FACILITY: Trojan Nuclear Plant

SUMMARY OF MEETING HELD ON OCTOBER 18 AND 19, 1979 WITH PORTLAND GENERAL ELECTRIC COMPANY AND BECHTEL TO DISCUSS THE TROJAN CONTROL BUILDING MODIFICATIONS

TROJAN CONTROL BUILDING MEETING

FIGURE 2-1

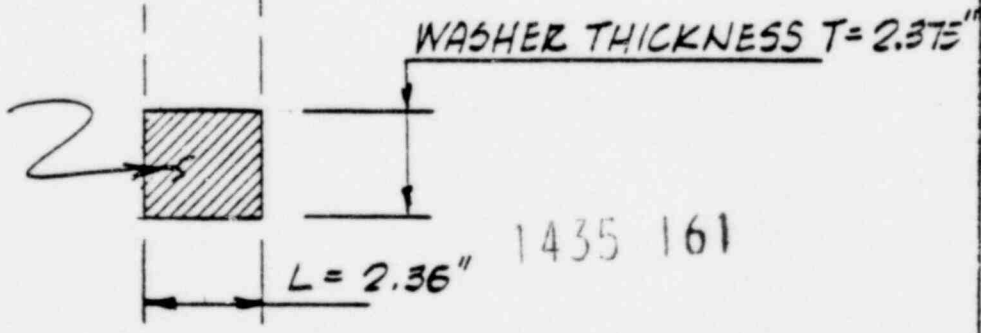
1. Provide a detailed description of how the equivalent diameter was determined which was used in computing the penetration of the dropped washer into the steel cover plate for cable trays.
2. Provide a drawing which illustrates the projected area used for computing the equivalent diameter.

The attached Fig. 2-1 shows the projected area used for computing the equivalent diameter of the plate washer impact.

14 SKETCH NO. 3-1

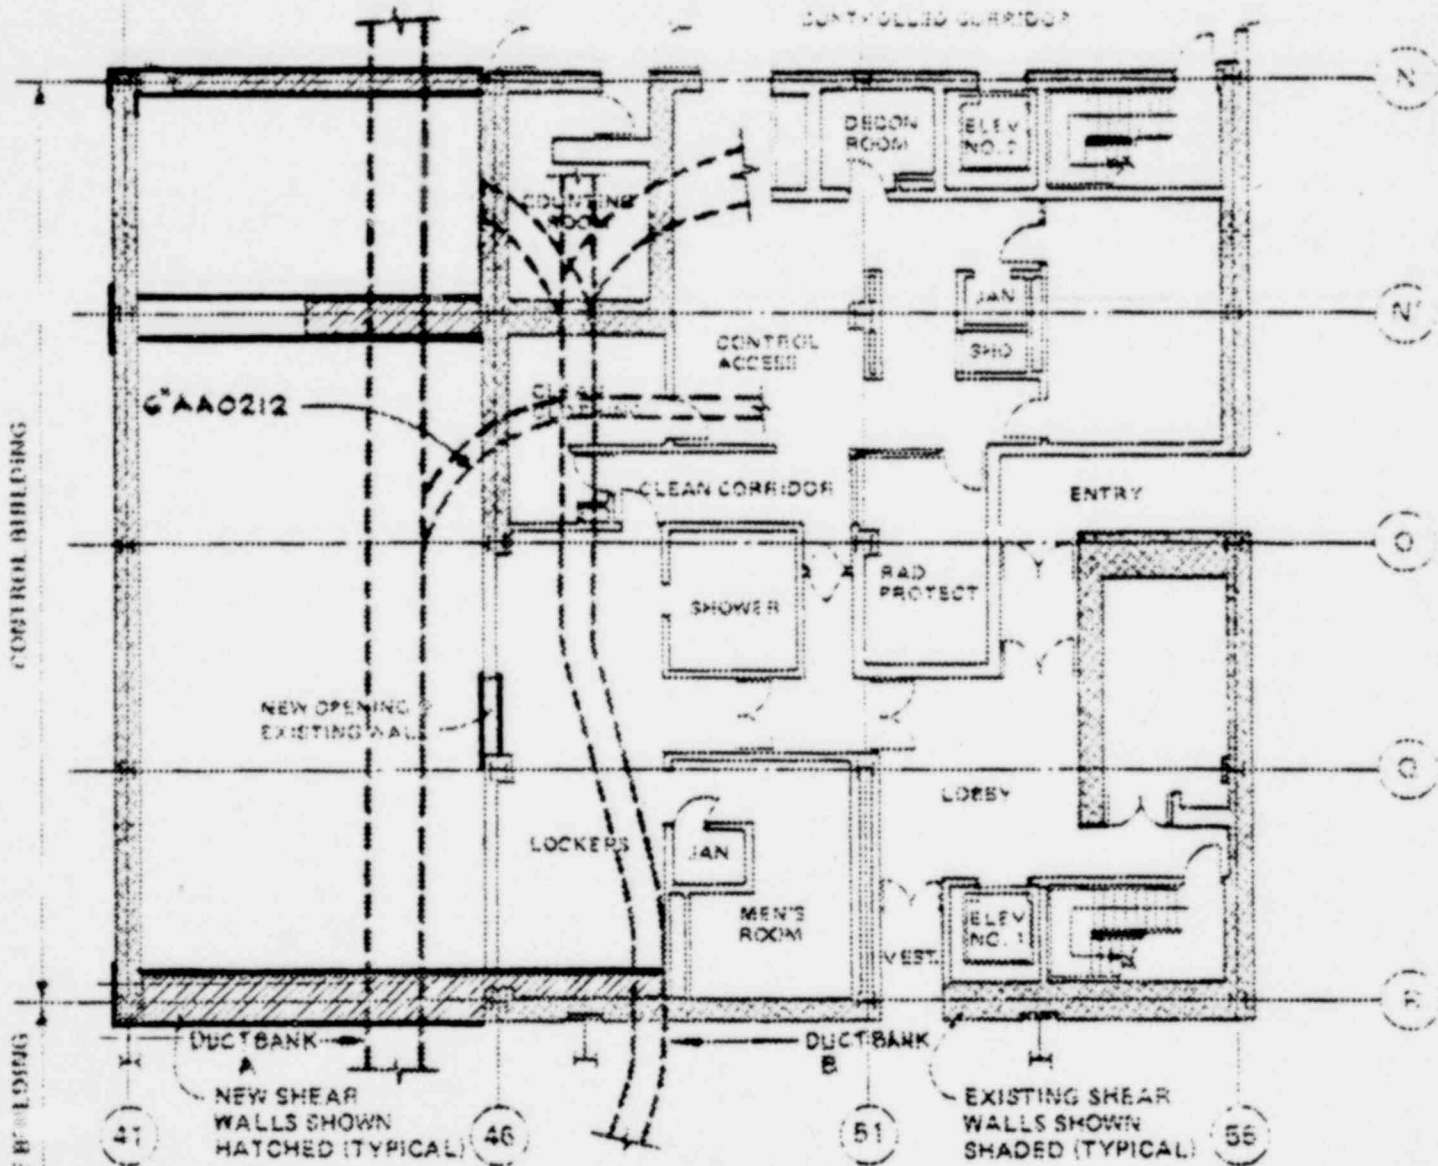
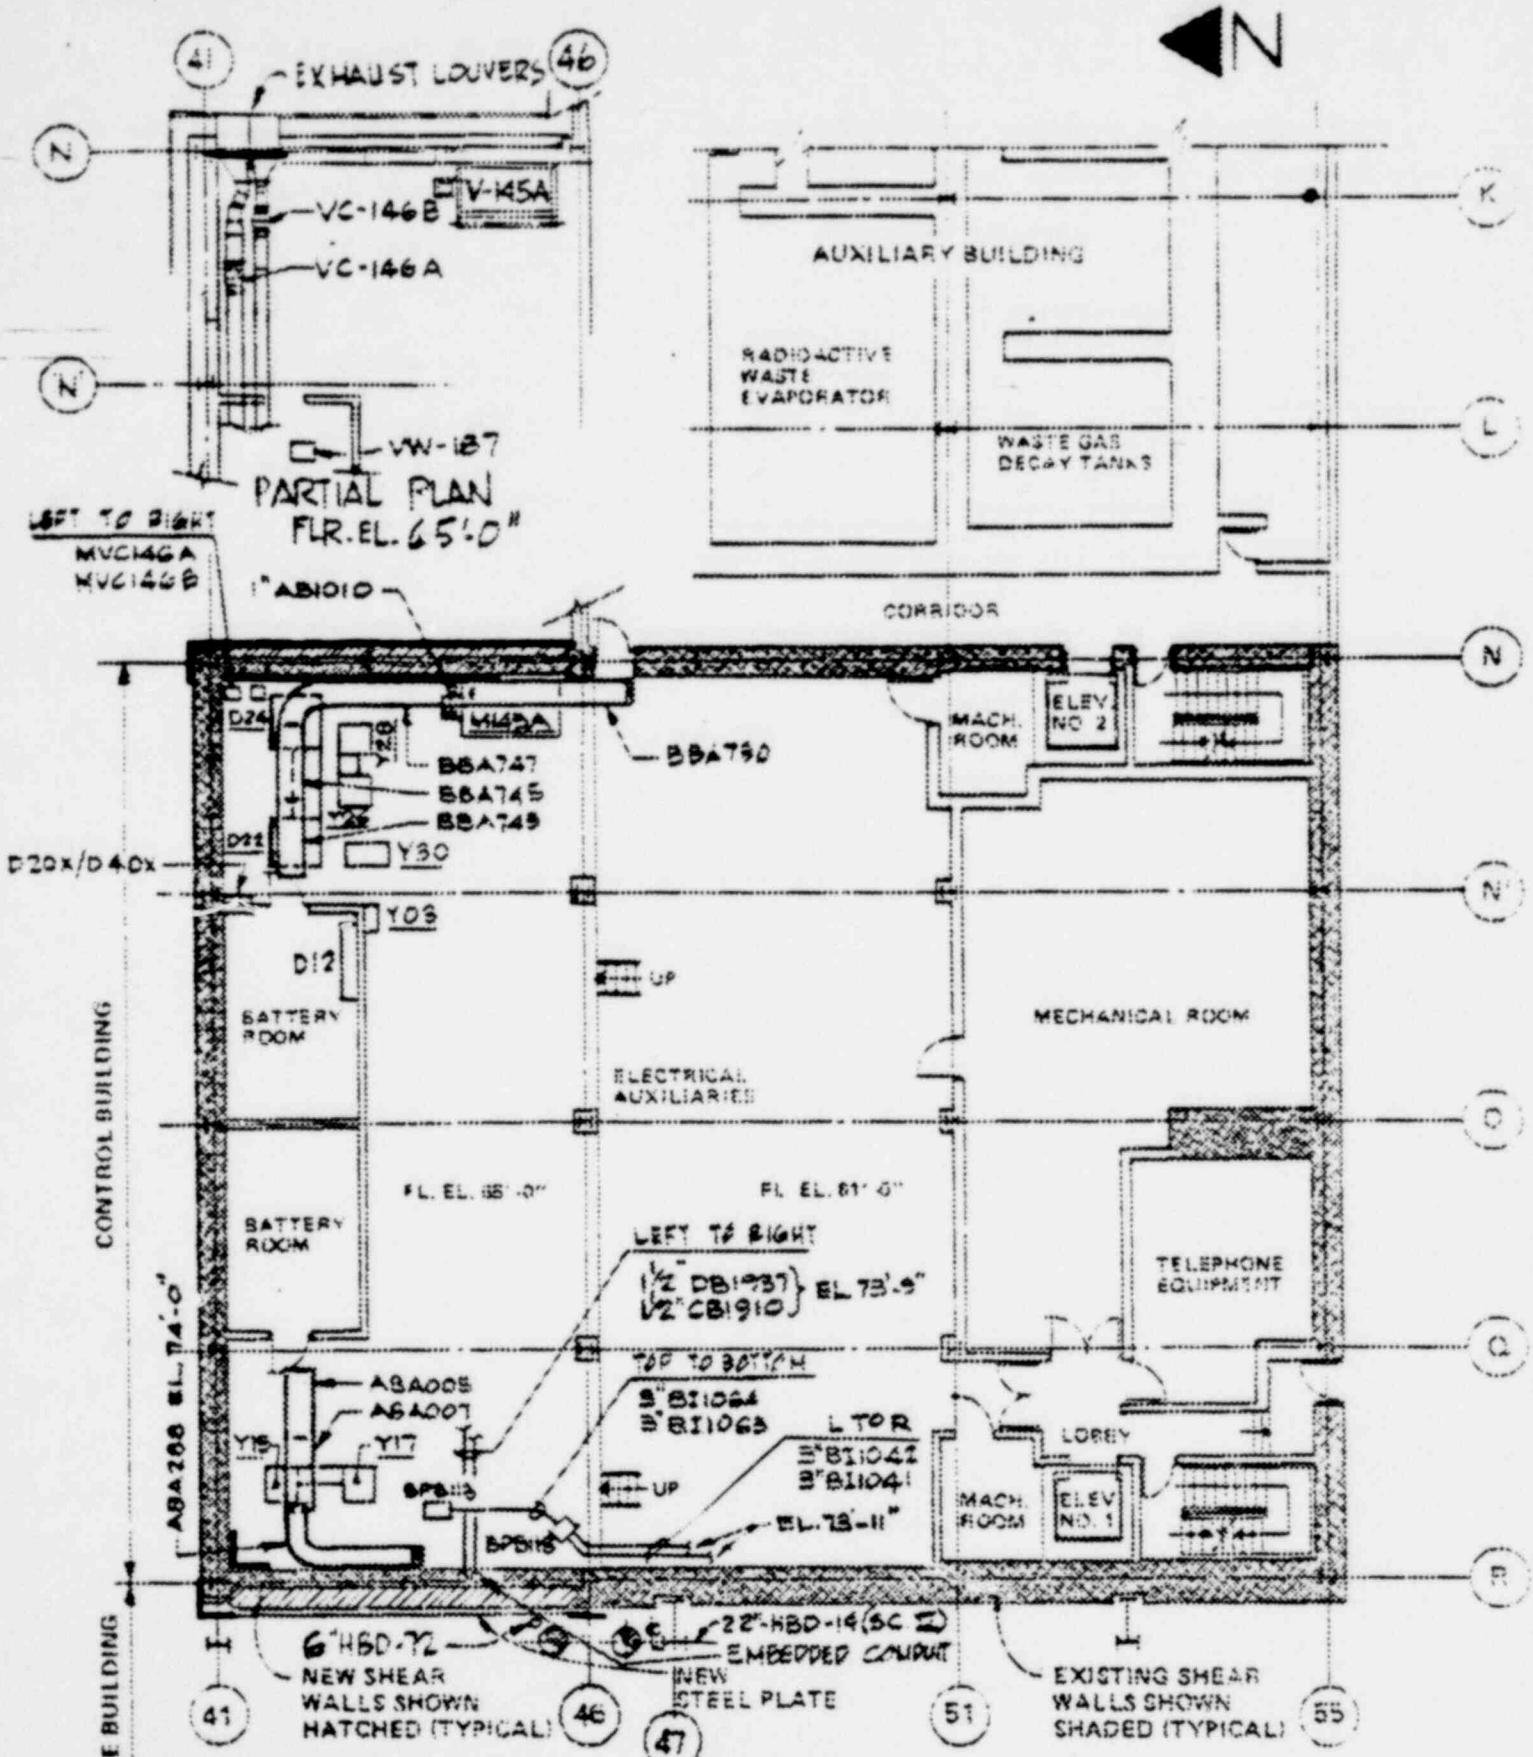
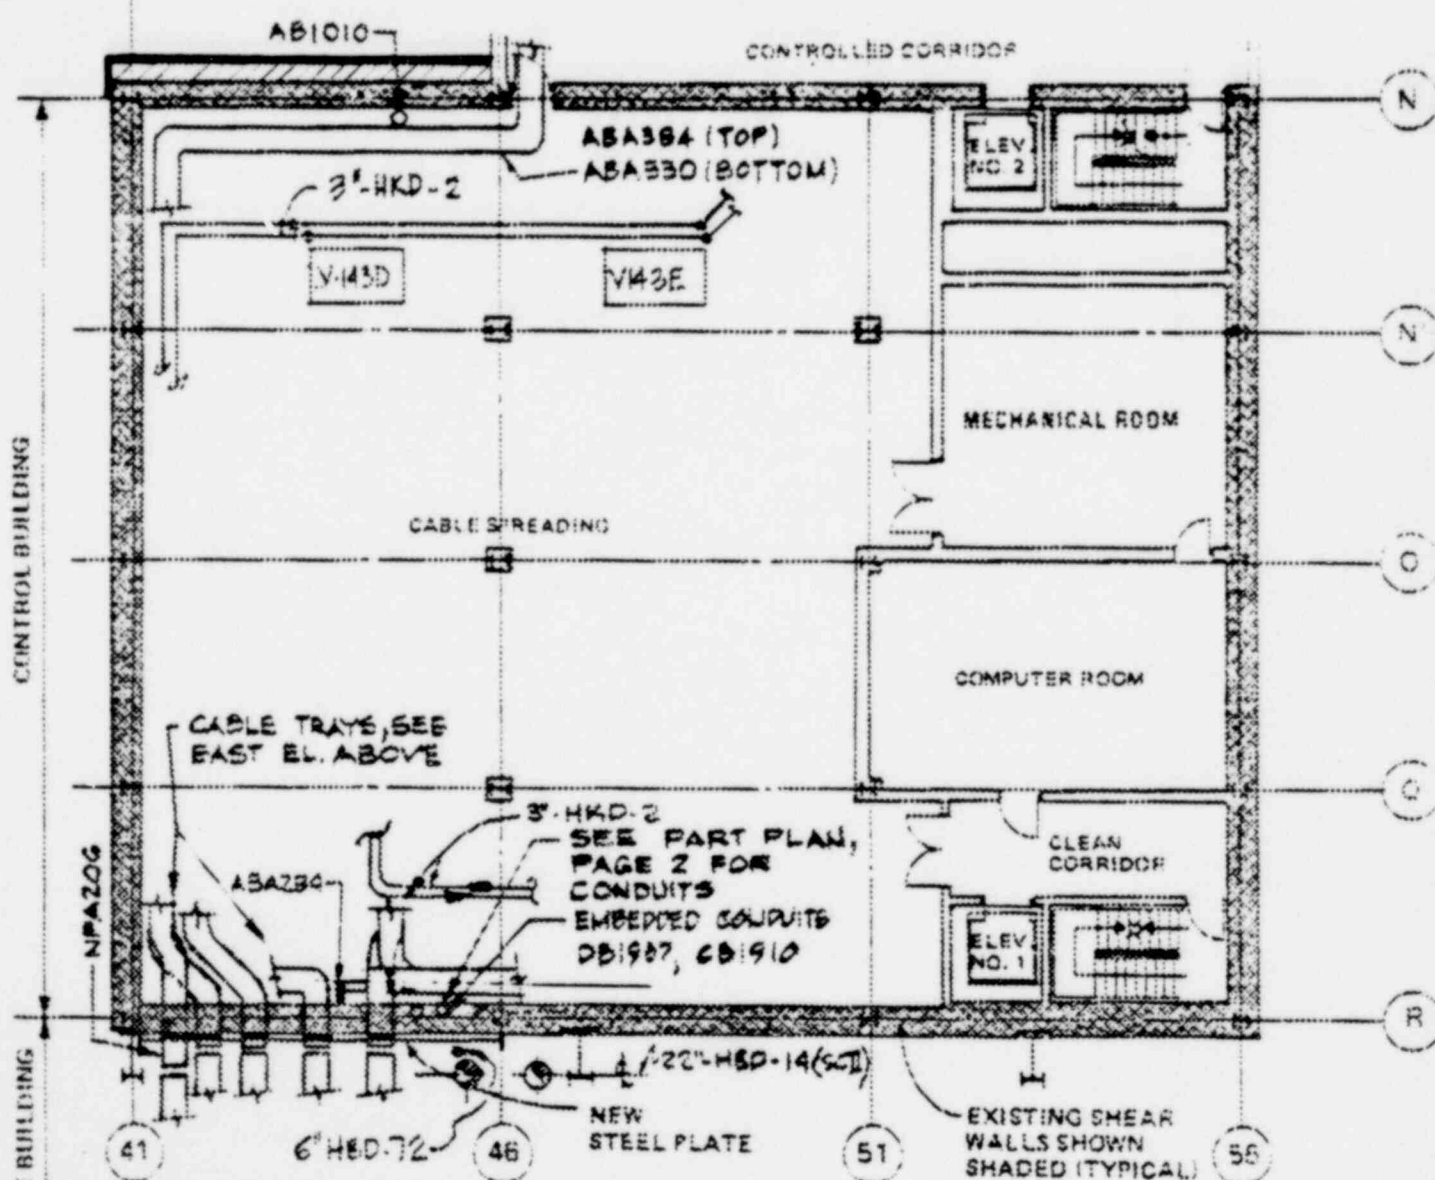
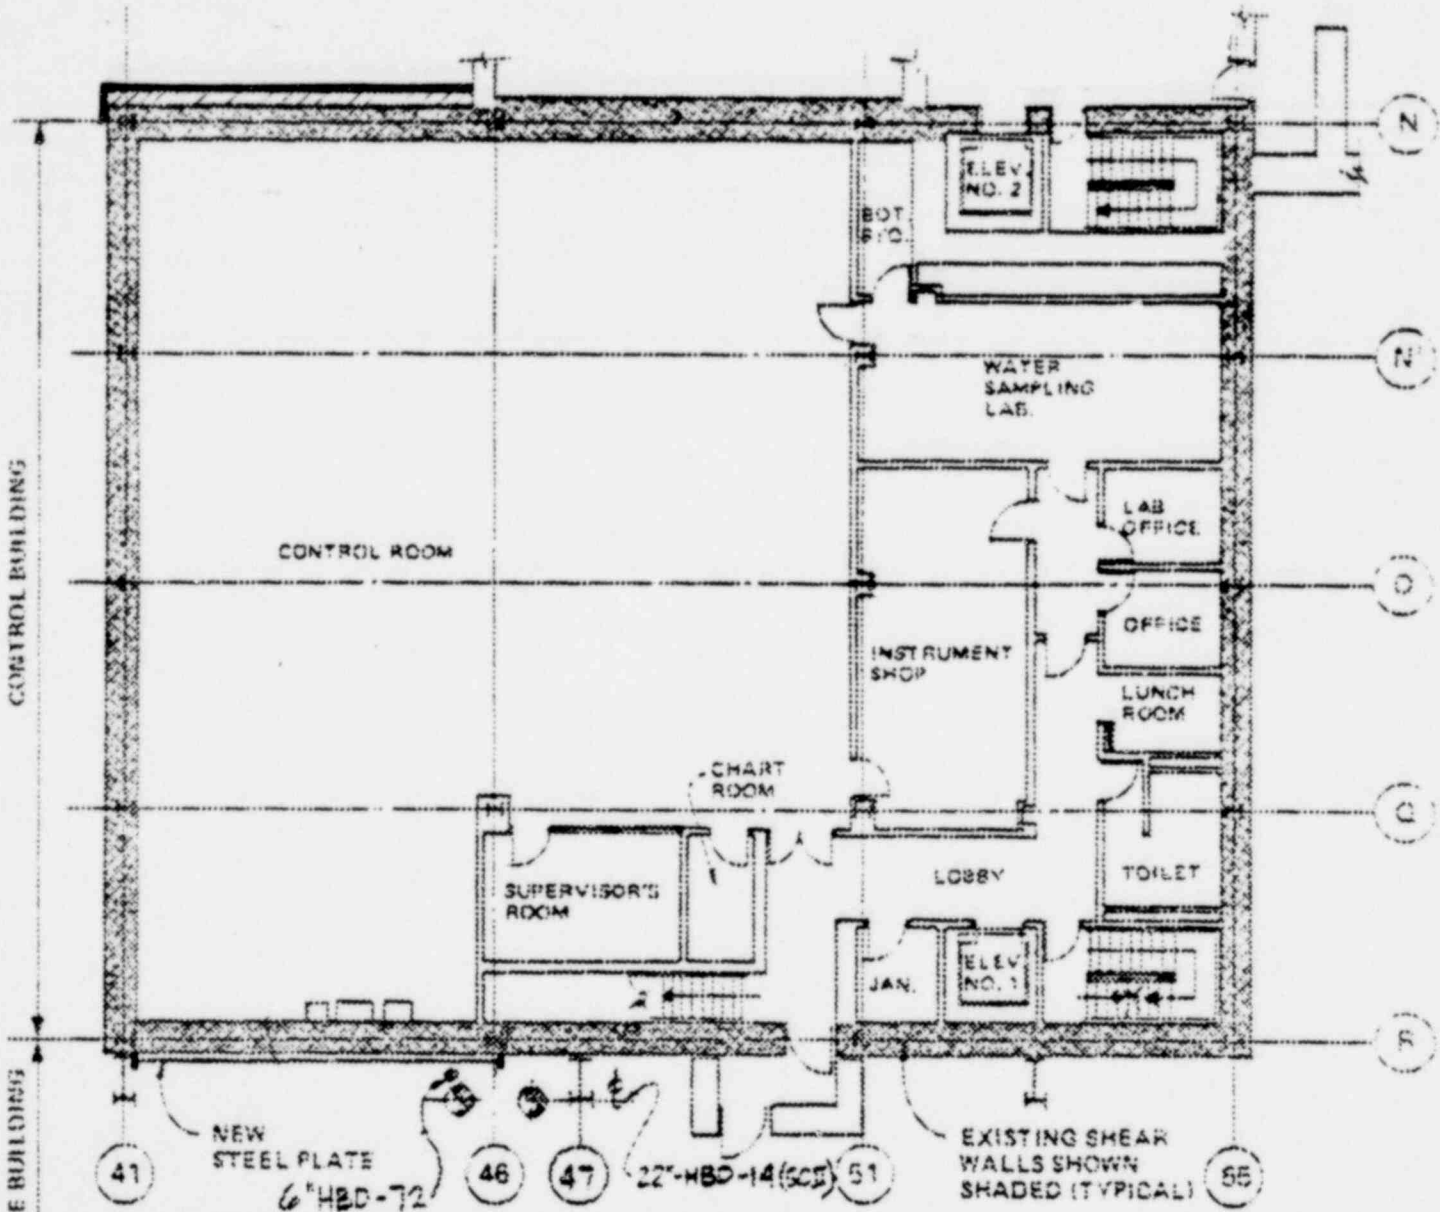
Provide a listing of all areas containing safety-related cables or equipment in which wood framing will be used during the modification work.

Figures 3-1 through 3-4 show locations of the above described wood form work. These figures are the same as attached to the answer to NRC Question No. 7, dated July 20, 1979.
